13460  
17 February 2014

**SECTION 96(1A) MODIFICATION APPLICATION - STATE SIGNIFICANT DEVELOPMENT  
APPLICATION NO. SSD-4972  
161 SUSSEX STREET, SYDNEY**

This modification relates to a number of small changes to the approved development that have arisen as a result of further design and engineering development by the project team.

Figure 2 – Proposed structural column design

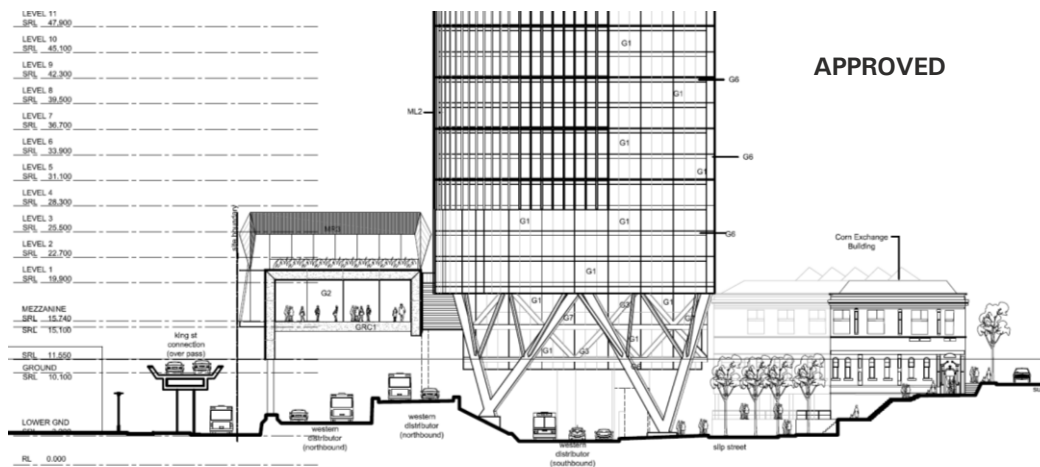
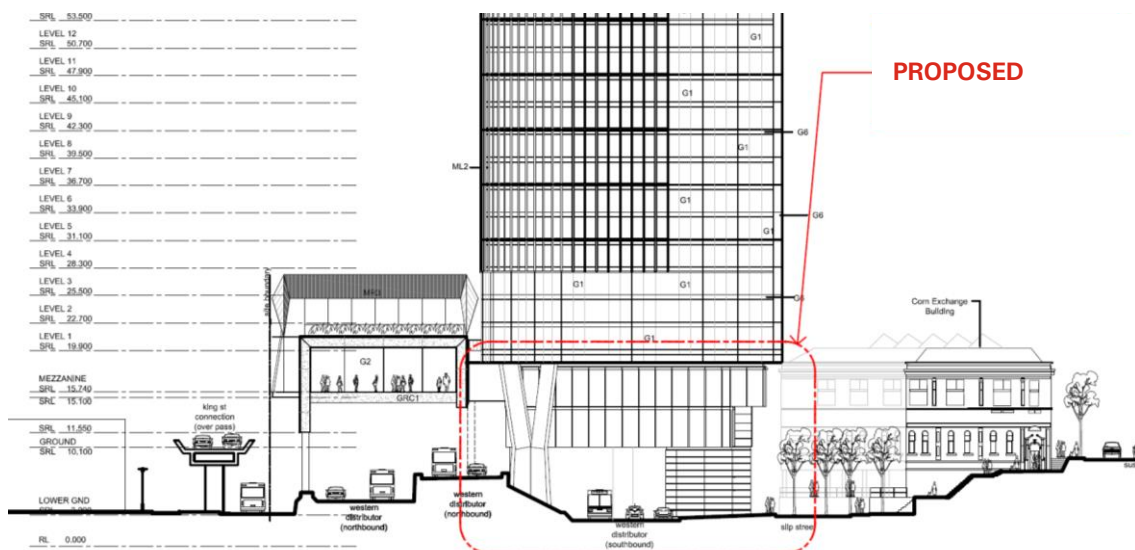
The alignment and configuration of the structural columns, trusses and footings beneath the approved tower have been amended following further design development and testing. The previous angular 'V' columns and trusses have been replaced with a rationalised structural support system that reduces the number and complexity of columns and beams. A comparison between the approved and proposed column configuration is shown in **Figures 1 and 2** and in the accompanying Architectural Plans (**Attachment B**).

Amendments to the structure beneath the approved tower have been made following further design and engineering work. The intention of these changes is to rationalise and simplify the structural form as this would deliver a number of benefits. Specifically it will:

The proposed changes also necessitate some minor amendments to the location of building footings. These new footings will be located along the median strip between the Western Distributor northbound and southbound lanes, providing an outcome consistent with the approved arrangement and importantly not altering or affecting the design of the road, its capacity and safety.

Figure 3 – Approved vs proposed location of structural columns and footings under convention space

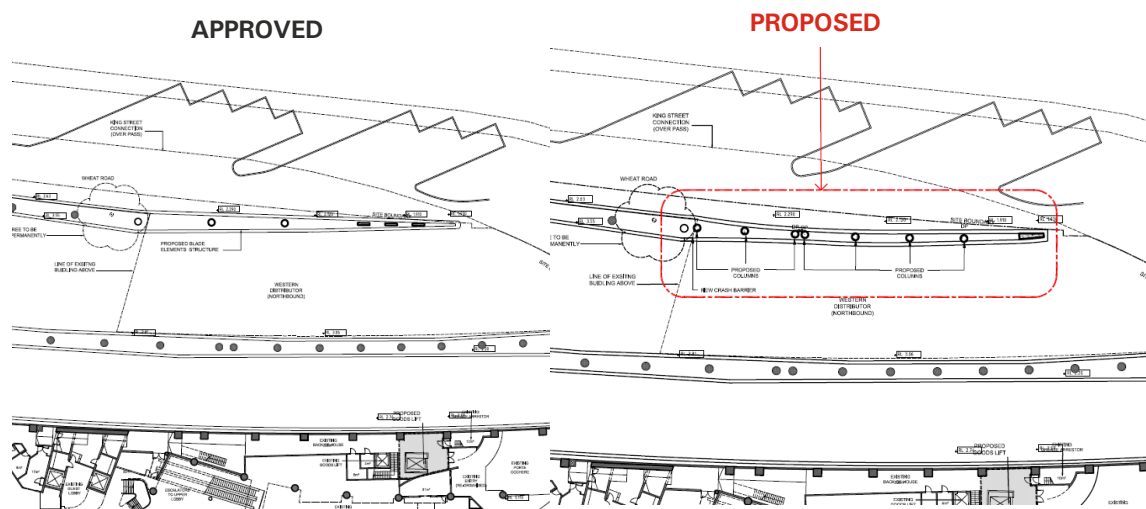
The configuration, location and number of structural columns and footings beneath the approved convention and function space are also proposed to be modified. The number of columns is to be increased from three to eight as shown in **Figure 3** below. The need for these additional columns has been identified following further structural and engineering analysis of the building design. Consistent with the existing approved development, the additional support columns will be located within the median strip between Wheat Road and the northbound lane of the Western Distributor. Further details are provided in the accompanying Architectural Plans (**Attachment B**).

These amendments involve the addition of five new structural columns beneath the building’s approved conference and function space. A structural and engineering review of the approved design identified a need for additional support columns, which are to be located along the median strip between Wheat Road and the northbound Western Distributor.

The new columns will be adjacent to the existing approved columns and will provide an outcome consistent with the approved development. The location and design of the columns beneath the building podium will ensure that they are obstructed when viewed from Darling Harbour.

Figure 4 – Approved vs proposed location of trees along Slip Lane

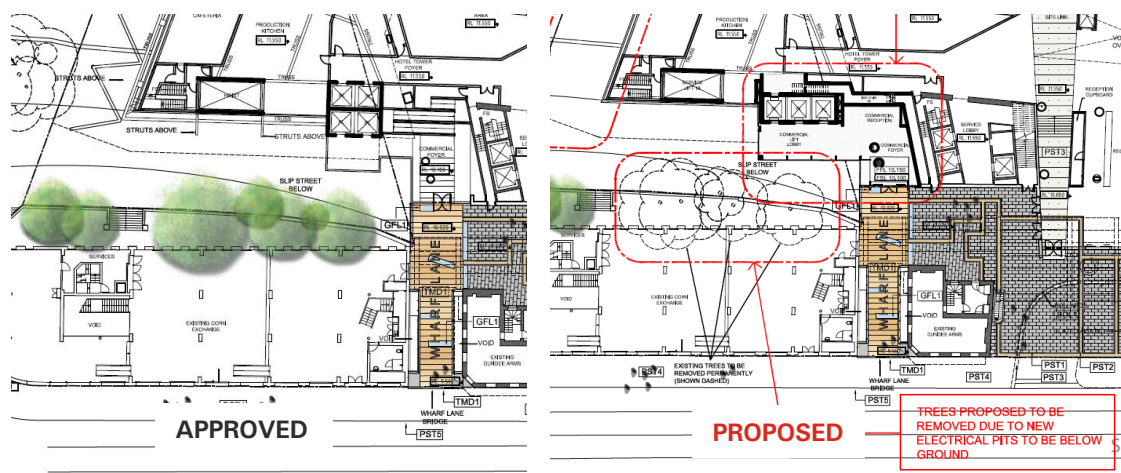
It is proposed to amend the approved development by removing a number of existing trees along Slip Lane and located between the approved tower and the Corn Exchange Building. Further detailed design work has identified that a number of electrical pits are required to be provided in this location and as such removal of these trees is necessary. **Figure 4** below between the approved and proposed development.

Figure 6 – Proposed conference/function space design

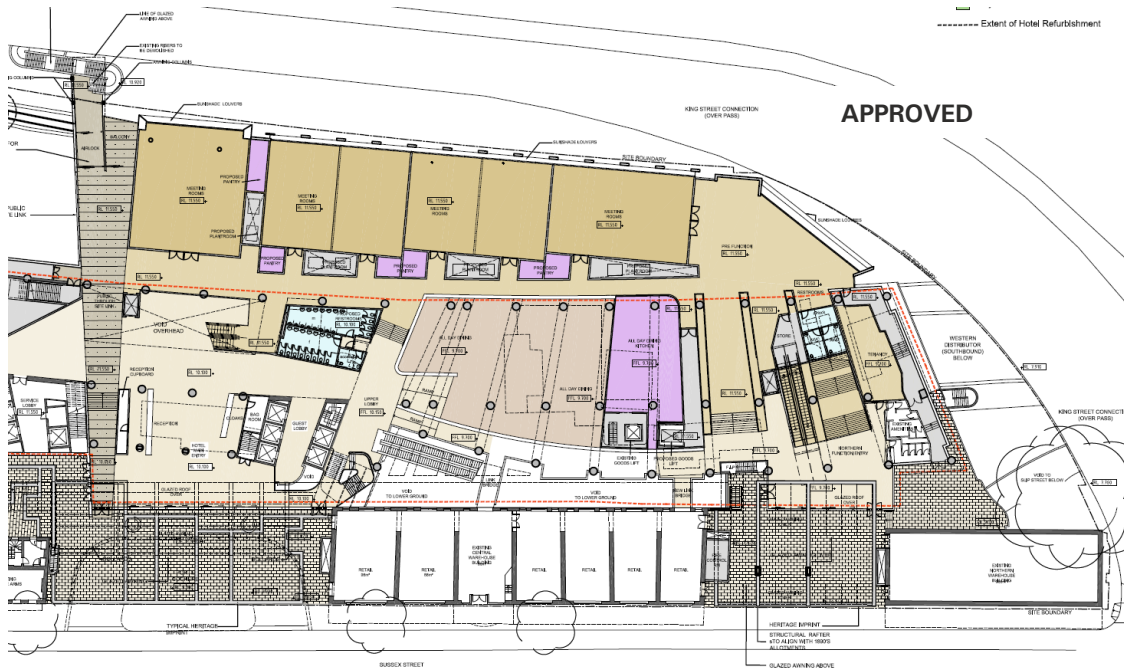
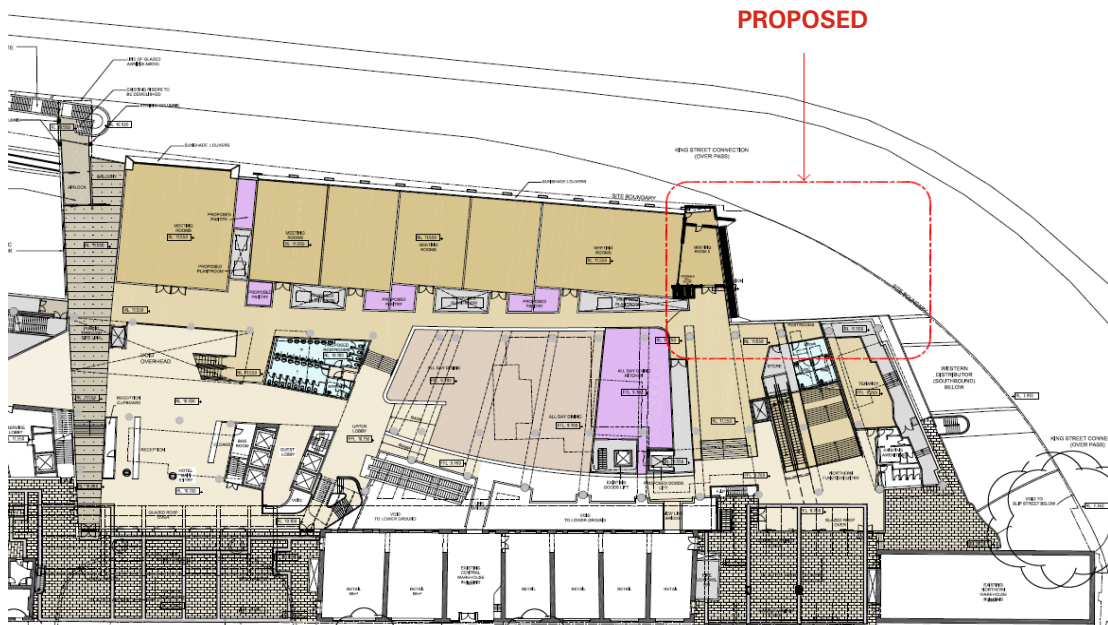
The approved pre-function area located at the northern end of the building is to be deleted and replaced with a smaller meeting room. The deletion of this area will reduce the development's overall floor space and result in a minor change to the building's appearance when viewed from the north and west. A comparison between the existing and proposed design solution is shown in **Figures 5 and 6** below. Further details on how the change will affect the building's appearance are provided in the accompanying Architectural Plans (**Attachment B**).

Figure 8 – Proposed lift core and lobby design

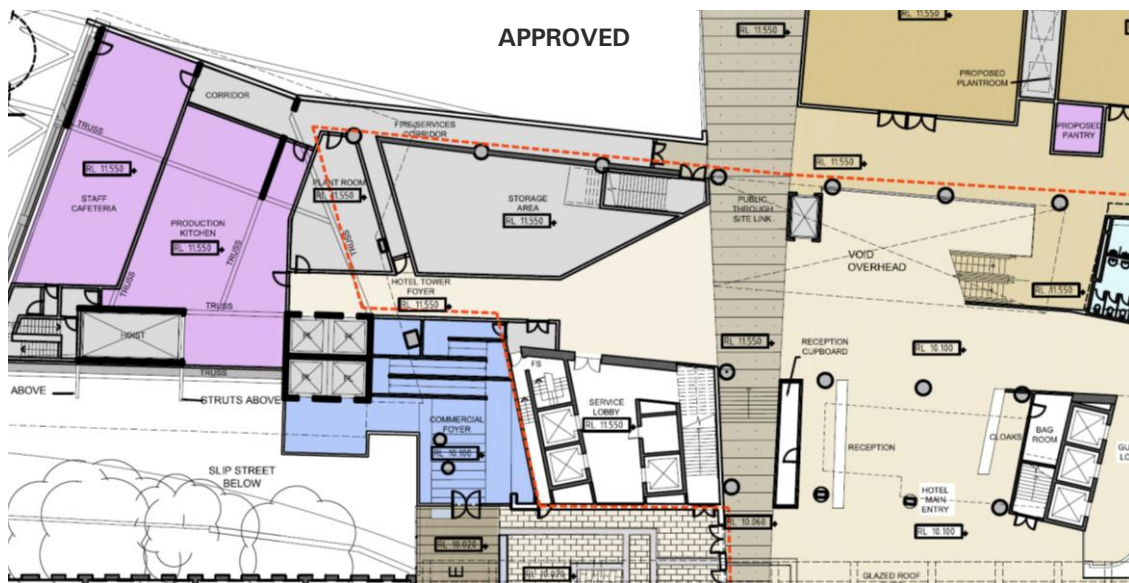
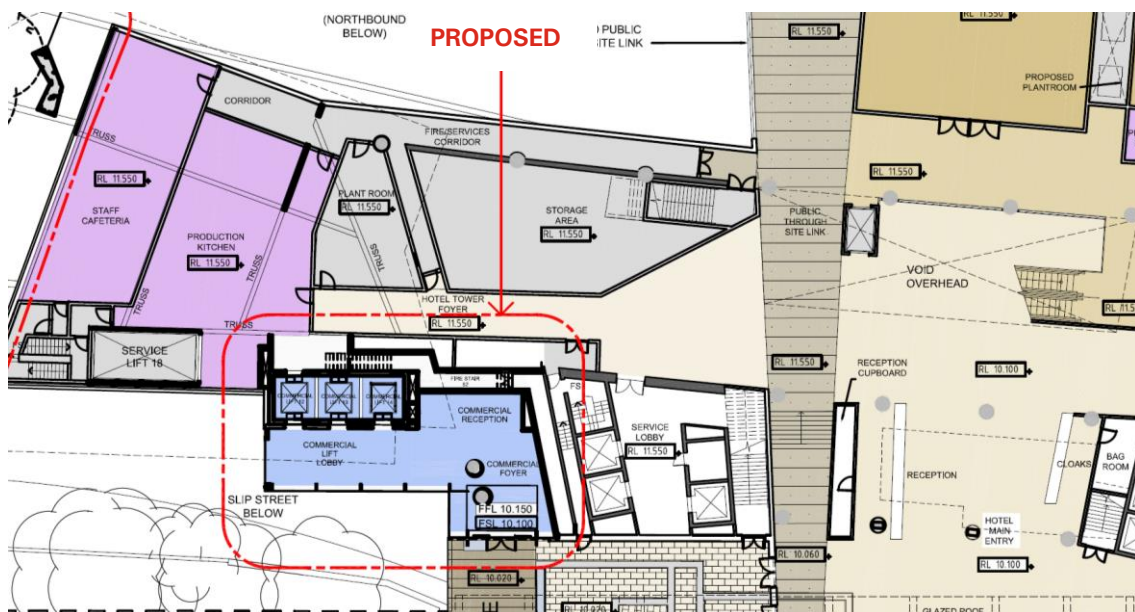
The commercial tower lift core is to be rationalised from four lifts to three. At present the approved building incorporates four lifts, with two of these serving the hotel up to Level 15 and the other two serving the building's commercial component. The current configuration has been identified as surplus to requirements with further research identifying that the new hotel rooms within the approved tower will be adequately serviced by the lift core located at the southern end of the existing hotel building. The four lift configuration has therefore been consolidated to three lifts that are now designed to solely service the building's commercial component. The revised core design has also allowed for the ground floor commercial lobby to be reconfigured as shown in **Figures 7** and **8** below. Further details are provided in the accompanying Architectural Plans located at **Attachment B**.

The rationalisation and redesign of the tower lift core and commercial lobby will result in the lift core reducing from four to three lifts from Ground to Level 15, and an increase from two to three lifts between Levels 16 and 22. The new hotel rooms will be serviced by the southern lift core within the existing hotel building while the revised building core provide a more effective service to the building's commercial component. The proposed change will also allow for an improved internal lobby and hallway space on each of the hotel levels.

The new core design also frees up space for a reconfigured and expanded ground floor commercial lobby, which in turn facilitates the creation of a more welcoming and enhanced arrival experience.

Figure 10 – Proposed western elevation of conference centre

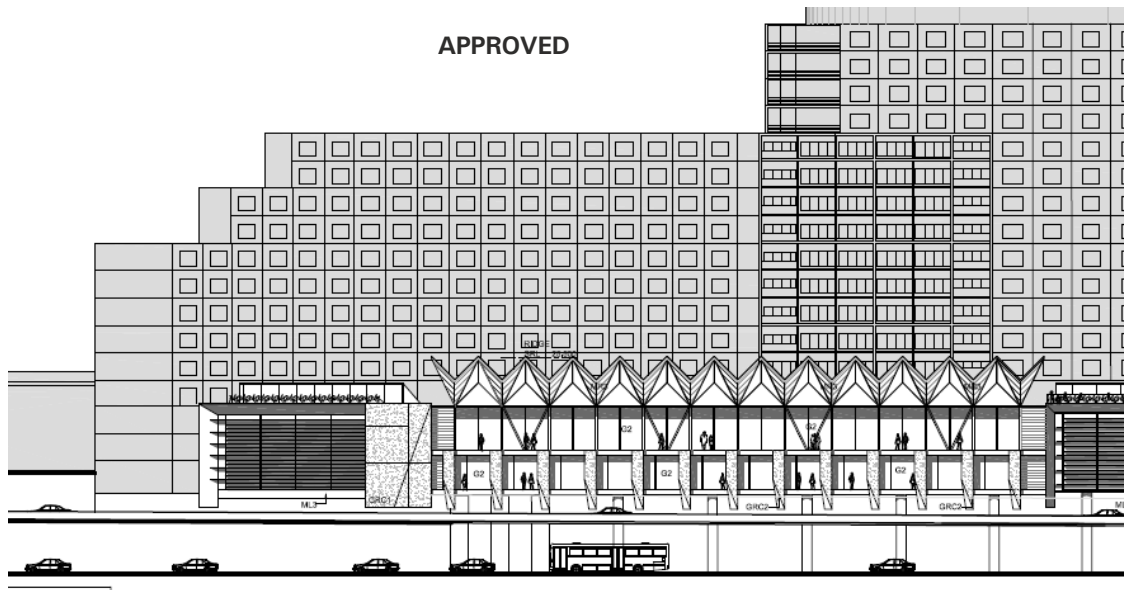
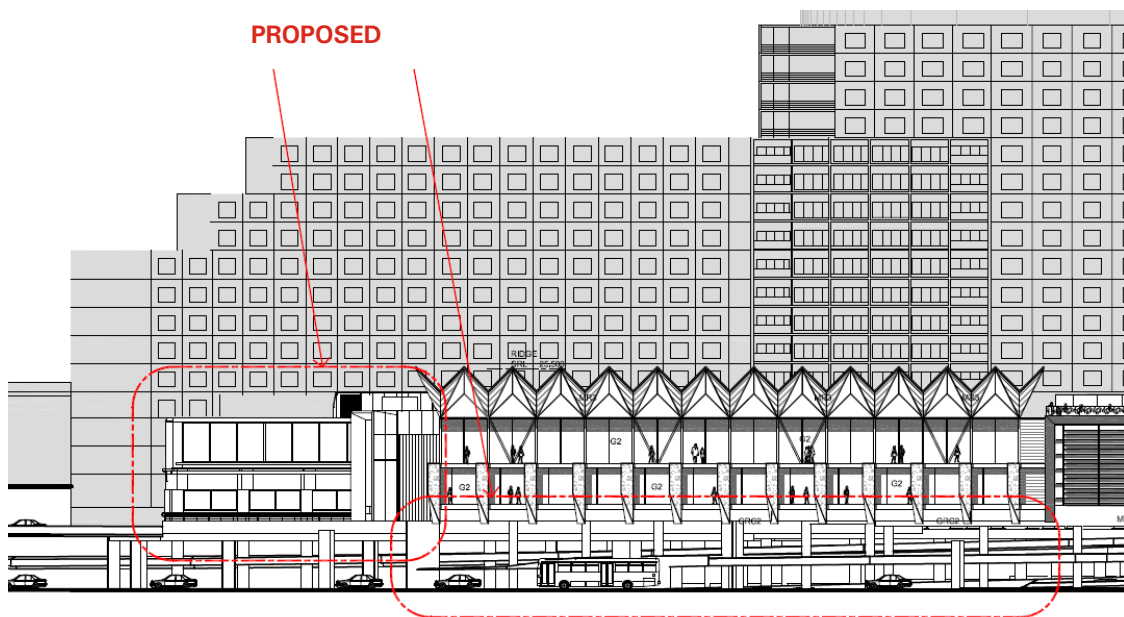
The approved pre-function area situated in the building’s north-west corner has been removed and replaced with a smaller meeting room. The proposed amendment results in some changes to the building’s appearance when viewed from the north and west, however these changes are considered minor and inconsequential in the context of the overall development. Specifically we note that:

- the building façade composition when viewed from the west and north continues to present in a consistent manner to that of the approved development. This is illustrated in **Figures 9 and 10** below;
- the building’s roofline remains consistent with the approved development, of particular note is the iconic sawtooth roof design is unchanged;

- the building continues to present an attractive, active and visually engaging facade to the north and west;
- the height and mass of this part of the building has been slightly reduced from that of the approved development;
- results in an improvement to the visual appearance of the building, with the revised design including glazing and building features that better complement the design of the existing approved facade.
